Subject: Revised manuscript with the reference number: nhess-2021-351

We would like to thank you for giving us an opportunity to revise our manuscript. We have addressed all the concerns comments and would like to submit our revised manuscript entitled "**Probabilistic Fault Displacement Hazard Analysis for North Tabriz Fault**" for further consideration.

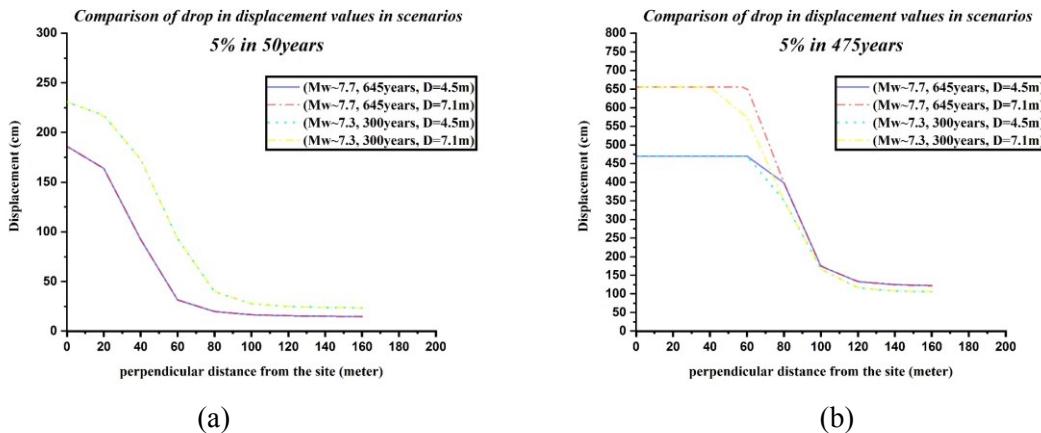
2) The input data must be clearly described both in the main text and in the figure. Fault length and selected site are just two examples.

In this section, in addition to re-editing the figures of the manuscript (figure 1), to introduce the input parameters, we also briefly explained these parameters in the introduction. Please see the introduction of the annotated manuscript.

Figure 9. Comparison of drop in displacement values in scenarios, a) 50years, b) 475years, c) 2475years

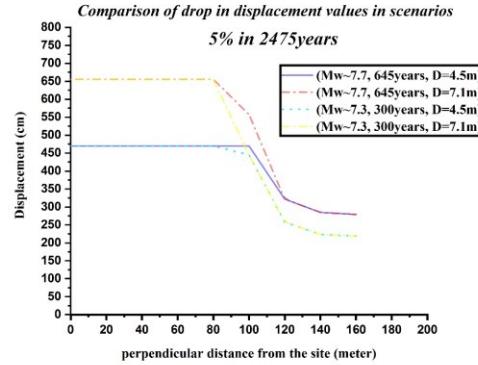
4) The section Results and Discussions is very poor. There is no discussion about the results and, for me, it has been very hard to understand how input parameters are considered and which equations are used. This paper could help the seismic hazard local community but it need a major review in order to make the manuscript clear and readable. Reading the paper I have the feeling that most of things are omitted and not well described.

To explain the results obtained more clearly, we added Figure 9 which examines and compares the results obtained for two different scenarios and identifies the worst case and will have a better description of the results obtained. Please see the "Results and Discussions" of the annotated manuscript.
